Appendix 14

Meadowbank and Whale Tail MDRB Report No.30

Report No 30
Meadowbank Mine Dike Review Board (MDRB)
Site visit September 13th to 16th, 2022.

RESPONSE TO COMMENTS, MEADOWBANK DIKE REVIEW BOARD No.30 – MEADOWBANK REPORT

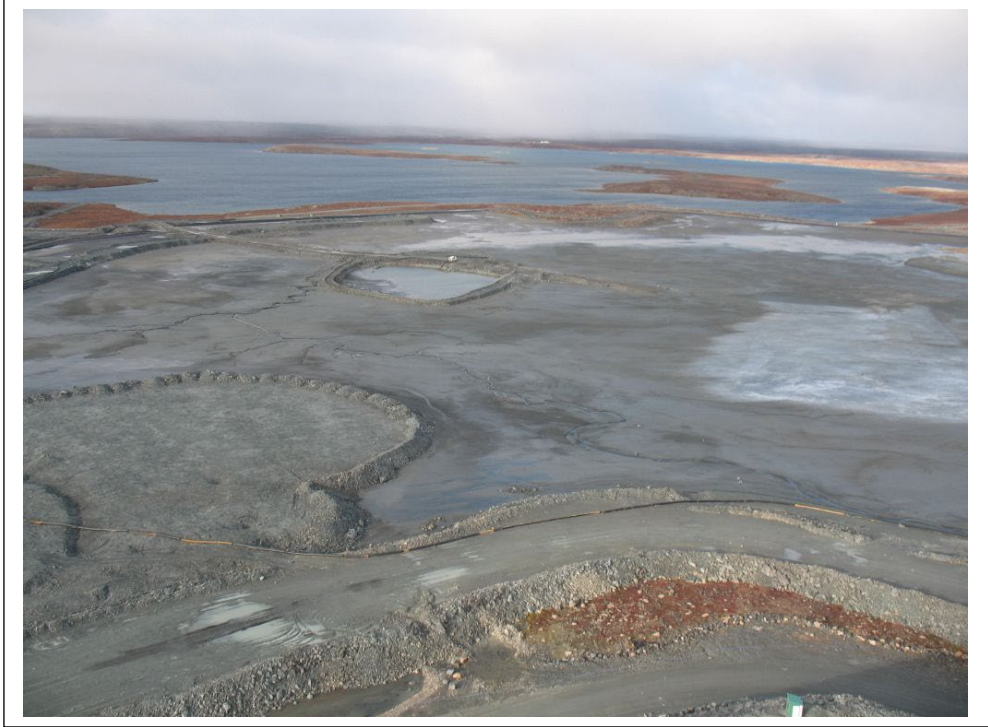
All ore from Meadowbank, Vault and Amaruq is processed at the Meadowbank facility and consequently the tailings are also deposited at this facility. The current tailings deposition, which is limited to that from Amaruq ore, is entirely “in-pit”. Deposition of tailings is currently into Pit E (photo #1). The available volume in the mined-out pits is deemed to be adequate for the current life of mine.

The reclaim of supernatant water is currently from Pit E (photo #2). As in previous years, some problems with reclaiming the supernatant water arose during the winter season. This exacerbates the fresh water consumption that AEM is endeavouring to minimize. AEM has the situation in hand and there are no comments from the Board.

Photo #7 Stormwater Dike

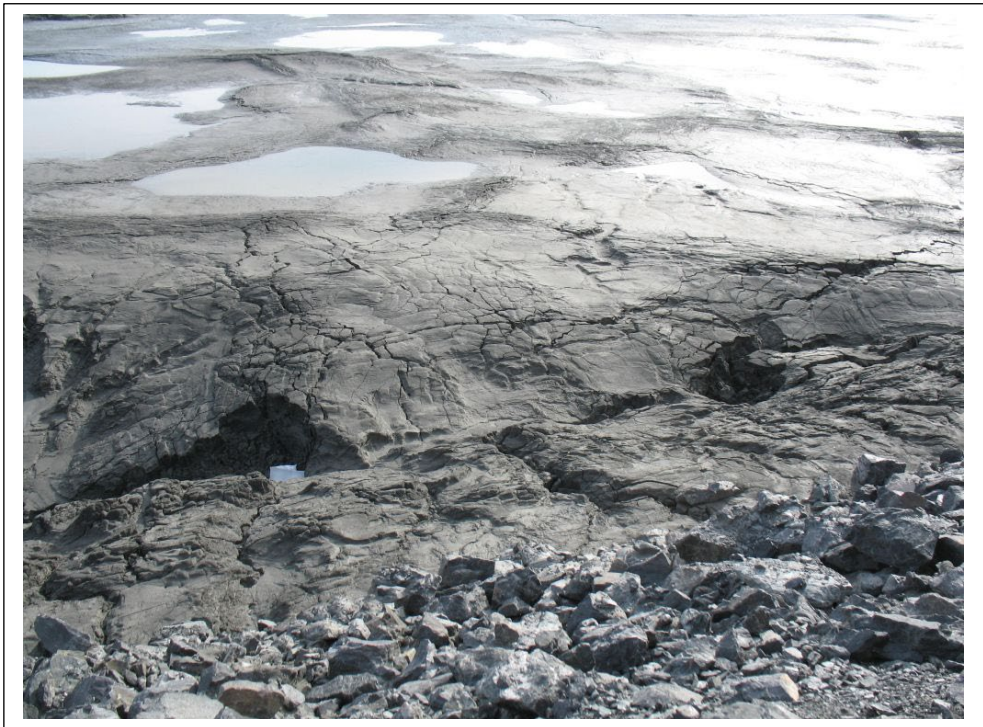
A fine crushed rock filter lines the inner slope of the NCIS and RF-2. As the annual geotechnical report notes, this material is subject to erosion from any water flow along the toe (photo #6), from seepage through or over the slope and constitutes an on-going maintenance item. The Board suggests that a berm of coarser rockfill be placed along the toe to alleviate this issue as the capping may still be several years in the future.

The situation at Stormwater Dike (photo #7) is little changed from last year. An area of shallow ponded water is noted at the west end. Down drag of ice or frozen tailings adhering to the liner is a possibility however, as the tailings deposit is at or about the maximum planned elevation little consequence is envisaged. Nevertheless, "landscaping" tailings deposition and/or the placement of finer material should precede the placement of the capping rockfill along the upstream crest.

MDRB#30-7	TSF	2022	A fine crushed rock filter lines the inner slope of the NCIS and RF-2. As the annual geotechnical report notes, this material is subject to erosion from any water flow along the toe (photo #6), from seepage through or over the slope and constitutes an on-going maintenance item. The Board suggests that a berm of coarser rockfill be placed along the toe to alleviate this issue as the capping may still be several years in the future.	AEM will develop a plan to place a berm of rockfill along the toe of the inner slope of the NCIS and RF-2 to prevent reoccurring erosion events.	Open	Jun-23
MDRB#30-8	TSF	2022	The situation at Stormwater Dike (photo #7) is little changed from last year. An area of shallow ponded water is noted at the west end. Down drag of ice or frozen tailings adhering to the liner is a possibility however, as the tailings deposit is at or about the maximum planned elevation little consequence is envisaged. Nevertheless, "landscaping" tailings deposition and/or the placement of finer material should precede the placement of the capping rockfill along the upstream crest.	As mentioned in recommendation MDRB#30-4 AEM agrees that additional tailings deposition needs to be performed at the North Cell to prepare the final tailings surface and is planning to complete this deposition in future summers; consideration will be made to add tailings at the west end of Stormwater Dike where water ponds. More details to come on this with the new tailings deposition plan to be released in the upcoming months.	Closed	-

Photo #16 Whale Tail Dike. Seepage collection ditch

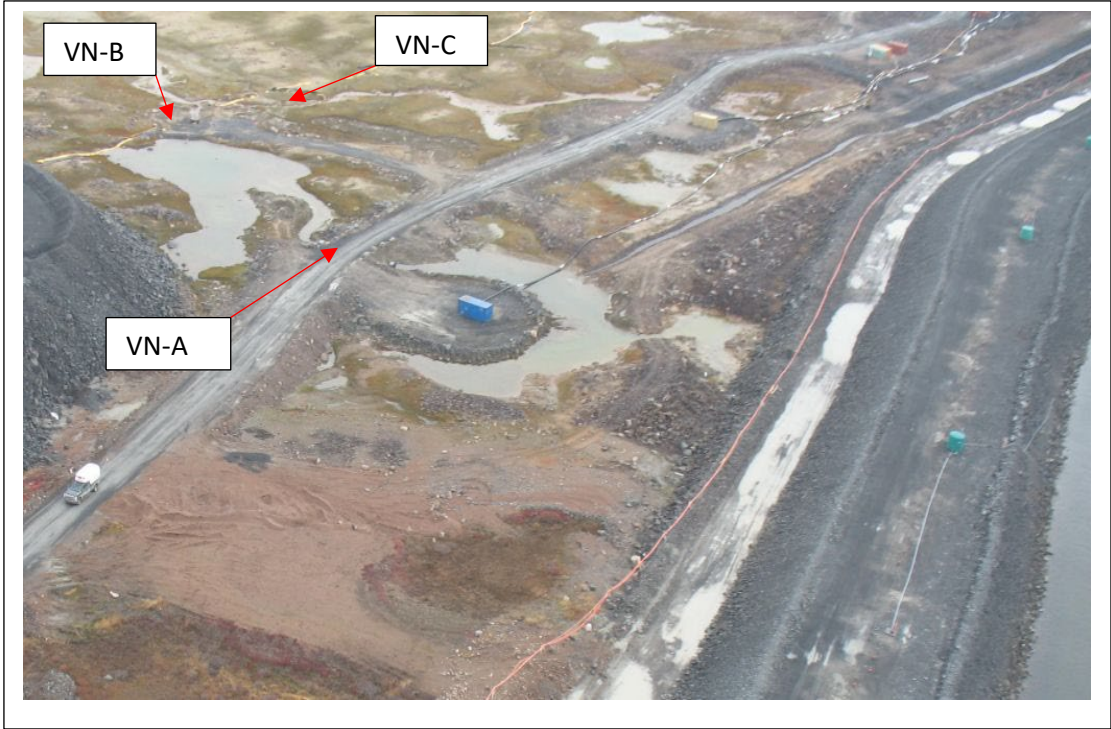
The dike (photo # 16) has been in operation since 2019. An initial grouting program extending from Stn. 0+180 to 0+516 was carried out in the unfrozen bedrock prior to dewatering the northern sector of Whale Tail Lake. Seepage and thaw of the foundation, particularly towards the East abutment, were noted shortly after commissioning. A remedial grouting program was undertaken from Nov 2019 to March 2020 and covered the stretch from Stn. 0+487 to 0+748. This had a successful outcome, insofar as considerable reduction in seepage, was achieved. However, seepage flow rates are not accurately documented, given that part of the seepage reports by surface flow to the attenuation pond and part becomes groundwater recharge. The seepage collection ditch, shown on photo #16 was modified in 2022 such that all surface water emanating from the dike toe now reports to the two weirs A and B (photos #17, 18 and 19) installed in series where a flow of about 100 m³/h is recorded. A few springs located downstream of the ditch are missed but from a temporary weir (C) the flow rate is estimated to be approximately 25 m³/h. There has been an improvement in the seepage collection system but the catchment is quite large and surface runoff “noise” in the measurements during periods of rain or snowmelt are likely. Good records of temperature and precipitation will be necessary to facilitate interpretation of data.

MDRB#30-16	WTD	2022	There has been an improvement in the seepage collection system but the catchment is quite large and surface runoff "noise" in the measurements during periods of rain or snowmelt are likely. Good records of temperature and precipitation will be necessary to facilitate interpretation of data.	AEM collects detailed records of temperature and precipitation and will use them in conjunction with the Whale Tail Dike seepage measurements to aid in interpretation.	Closed	-
MDRB#30-17	WTD	2022	The Board recommends the construction of a berm in this location. The rock groin seen in photo #20 could be continued to meet the dike embankment thus providing protection against wave attack and the area behind this groin filled with sand and gravel material to chase water out of the depression in order to facilitate ground freezing during the upcoming winter season. A lift of about 1 m thickness is proposed initially with additional granular fill added in late winter. Migration of sand particles into the dike fill would not be detrimental and would actually reduce inflow and outflow of water.	Following MDRB#30 AEM designed and constructed the first stage of the berm on the upstream east abutment of Whale Tail Dike. The second stage of the berm will be added in late winter. An update on the construction and performance of this berm will be given during the next MDRB meeting. AEM would like to thank the Board for their recommendations on the design of this berm.	Ongoing	Apr-23

Photo #20 Whale Tail Dike. East abutment

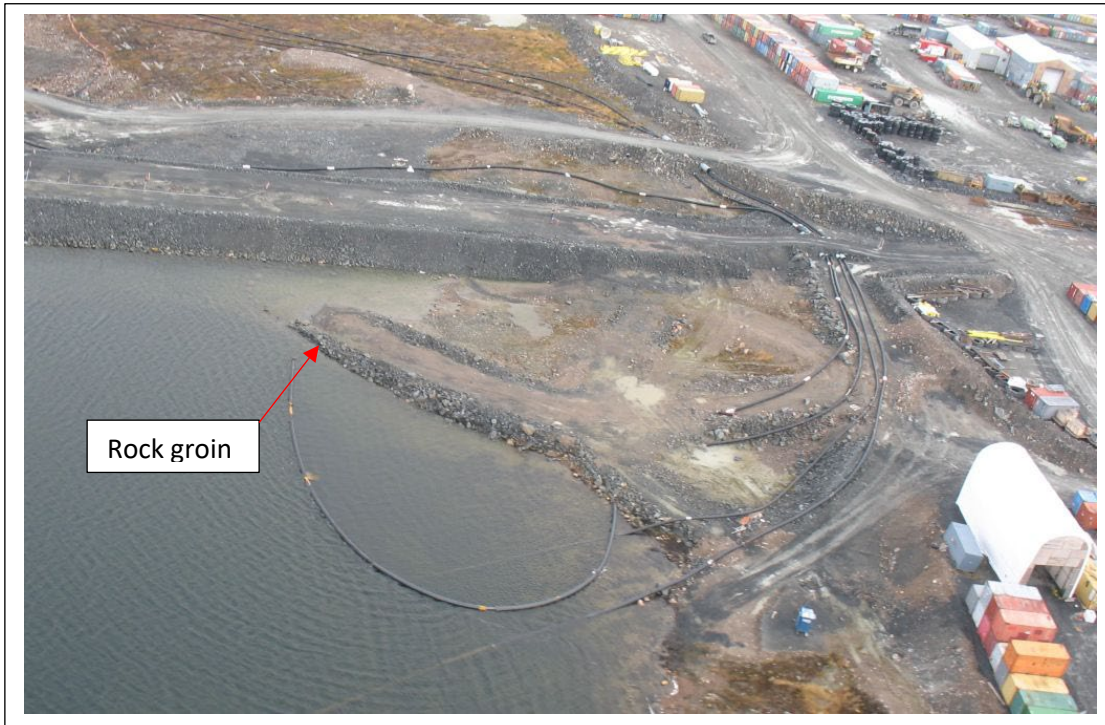
The on-site team has been monitoring deformation of the embankment in the vicinity of the East abutment (photo #20) and the Board was able to observe the situation. Foundation preparation for the dike involved the excavation of overburden and ground ice in the abutment area. This

The Board recommends the construction of a berm in this location. The rock groin seen in photo #20 could be continued to meet the dike embankment thus providing protection against wave attack and the area behind this groin filled with sand and gravel material to chase water out of the depression in order to facilitate ground freezing during the upcoming winter season. A lift of about 1 m thickness is proposed initially with additional granular fill added in late winter. Migration of sand particles into the dike fill would not be detrimental and would actually reduce inflow and outflow of water.

MDRB#30-18	WTD	2022	Some settlement, though of lesser magnitude, is observed on the downstream shoulder. The secant pile central cut-off is robust and the Board does not envisage a risk to dike integrity but the upstream remedial work should proceed without delay. The downstream East abutment area was noted to generally slope toward the toe of the dike. Regrading this area by fill placement would also minimize concentrated flows or water ponding against the toe, thus reducing the potential for further thermal degradation in this area.	AEM will evaluate whether there is water ponding or concentrated flow in that sector and if it requires mitigation. If its the case the possibility of regrading the downstream east abutment area of Whale Tail Dike will be examined.	Open	Jul-23
MDRB#30-19	WTD	2022	Thaw is also indicated by the thermistors at the West abutment and the addition of a thermal berm at this location is also worthy of consideration.	AEM has designed and is proceeding through the permitting process to be ready to build a thermal berm along the western abutment in the winter of 2023. Thermal data will be re-assessed in Q1 2023 to inform on whether this construction will be done at the same time as the Eastern thermal berm or at a later date.	Open	Apr-23

Photo #23 Whale Tail Pit, south wall

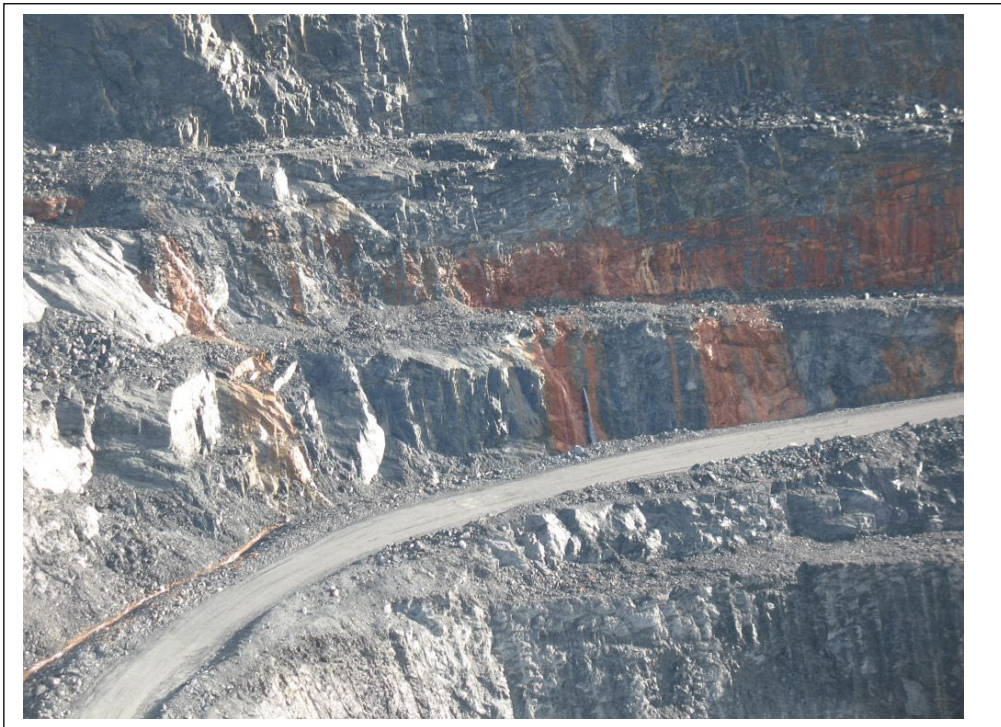
Seepage from the Whale Tail Dike area reports to the attenuation pond located in the vicinity of the Whale Tail Pit (South side). Seepage is noted on the south-east wall of the Whale Tail Pit (photo #23 and #24) and significant ice accumulation has been observed above the ramp. A push-back of this wall is currently underway as can be appreciated in the upper part of photo #23. The intent is to excavate a sump on the wide bench and to control by pumping the water flow that daylight on this North facing pit wall. This may be an optimal solution. However, depending on hydro-geological conditions, and the shape of the drawdown cone, water may still exit on to the pit wall at a lower elevation. If geological mapping reveals a significant conductor, the drilling of a pump well could be considered.

Recommendation Number	Location	Year ⁽²⁾	Recommendation	Action Plan/Follow-up	Status	Completion Date
MDRB#30-21	Whale Tail Pit	2022	The intent is to excavate a sump on the wide bench and to control by pumping the water flow that daylights on this North facing pit wall. This may be an optimal solution. However, depending on hydro-geological conditions, and the shape of the drawdown cone, water may still exit on to the pit wall at a lower elevation. If geological mapping reveals a significant conductor, the drilling of a pump well could be considered.	AEM has evaluated this option with Golder in 2021. It was found at the time that the hydrogeological condition of the pit would not be favorable to this mitigation technique. More details on this study could be shared with the Board at their request.	Closed	-
MDRB#30-22	TSF	2022	A re-arrangement of the SC of the TSF may be useful to reduce groundwater recharge and minimize seepage which exits at Central Dike.	AEM agrees that re-arranging the South Cell could be beneficial for water management, particularly for the Central Dike seepage. Additional tailings deposition needs to be performed at the South Cell to prepare the final tailings surface and high priority will be given to improving water management; more details to come on this with the new tailings deposition plan to be released in the upcoming months as well as the results of the ongoing study on the closure landform.	Ongoing	-
